Florida Department of Transportation

February 14, 2007

SUBJECT: Temporary Design Bulletin C07-1
Roadway Design Bulletin 07-3
Bridge Widening and Rehabilitation

This design bulletin clarifies the requirements for bridge widening and rehabilitation. These clarifications will be integrated into the "Plans Preparation Manual" Volume 1 and the "Structures Manual", Volume 1 - Structures Design Guidelines.

Figure 7-5
 Widening / Rehabilitation Decision Flow Chart

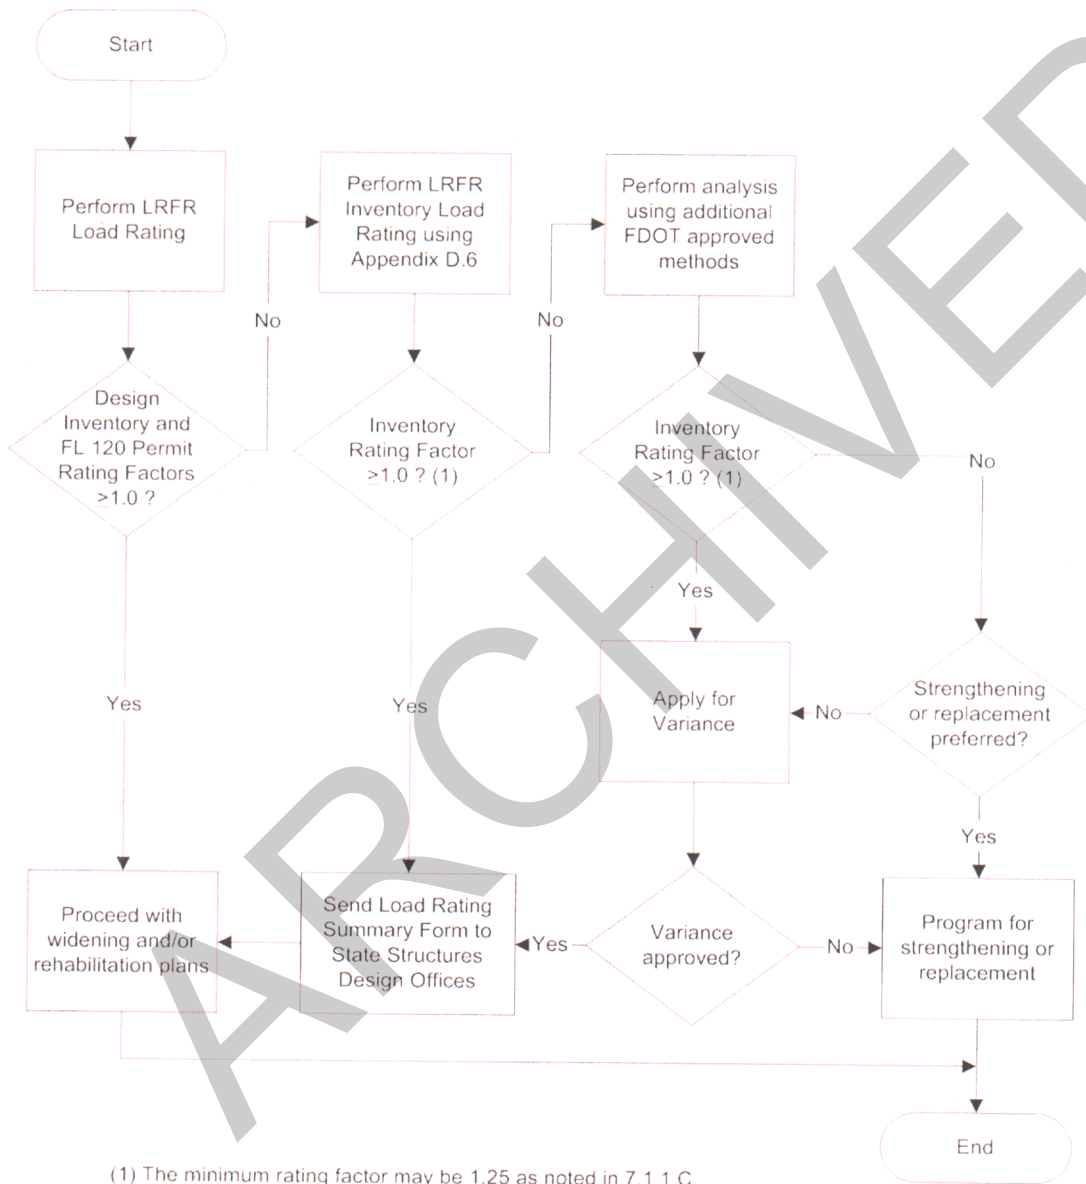
- A. Before preparing widening or rehabilitation plans, review the inspection report and the existing load rating. If the existing load rating does not represent the condition of the bridge, perform a new load rating of the existing bridge in accordance with ***SDG 1.7***. Design all bridge widening or rehabilitation projects in accordance with ***SDG 7.3***. If the bridge to be widened/rehabilitated does not have a design or permit load rating at inventory level of equal to or greater than 1.0, regardless of the specification used, replacement or strengthening is required unless a variation/exception is approved.

- B. If the widening or rehabilitation of a bridge does not produce a ***LRFR*** design inventory rating factor or a FL 120 permit rating factor greater than or equal to 1.0, calculate and report the appropriate rating factors using ***LRFR Appendix D.6*** and send a copy of the Load Rating Summary and the Load Rating Details in the ***Structures Manual Vol. 8*** to the State Structures Design Office. Calculate ratings for concrete box girders (segmental) using ***LRFR Appendix E.6***.

- C. If the load rating at inventory level using ***LRFR Appendix D.6*** yields a design inventory rating factor of less than 1.0 or 1.25 for cast-in-place and precast flat slab bridges, the use of the additional methods of analysis listed below may be approved for use by the Department. The use of these methods of analysis requires a variance approved by the State Structures Design Engineer.

For a process chart of the widening/rehabilitation decision making process, see **Figure 7-5**.
